STATE OF UTAH
DEPARTMENT OF NATURAL RESOURCES
DIVISION OF OIL, GAS AND MINING

APPLICATION FOR PERMIT TO DRILL			5. MINERAL LEASE NO: ML-46532	6. SURFACE: State
1A. TYPE OF WORK: DRILL <input checked="" type="checkbox"/> REENTER <input type="checkbox"/> DEEPEN <input type="checkbox"/>			7. IF INDIAN, ALLOTTEE OR TRIBE NAME:

2. NAME OF OPERATOR: KERR MCGEE OIL & GAS ONSHORE L.P.			9. WELL NAME and NUMBER: LOVE 1121-16M	
3. ADDRESS OF OPERATOR: 1368 S 1200 E CITY VERNAL STATE UT ZIP 84078		PHONE NUMBER: (435) 781-7024	10. FIELD AND POOL, OR WILDCAT: UNDESIGNATED

Application for Permit to Drill

SCALE: 1" = 1000' DRAWN BY: C.P. REVISED: 04-16-07

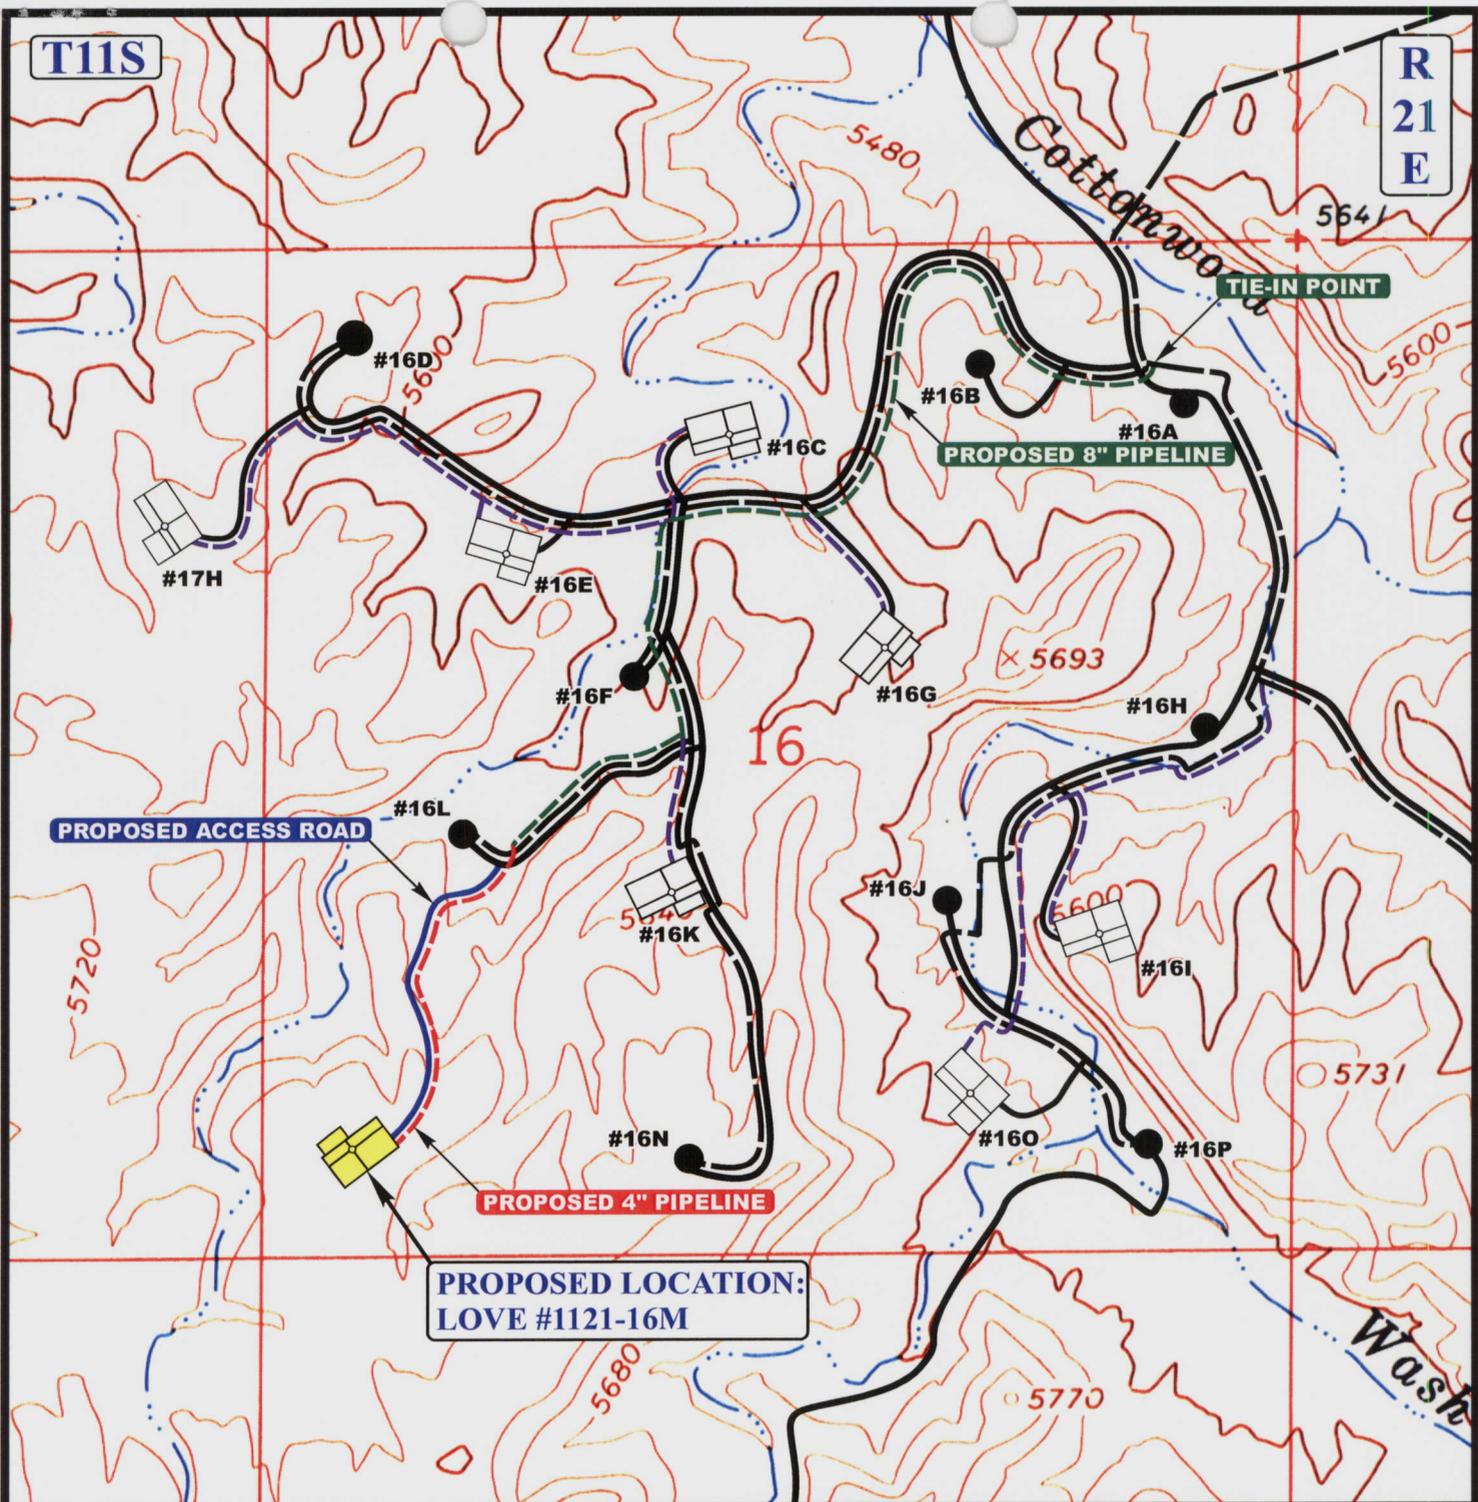
An onsite was conducted on 4/4/07 with the Division of Oil, Gas and Mining Representative and SITLA Representative. It was decided to add an 8" pipeline approximately 6,000' +/-.
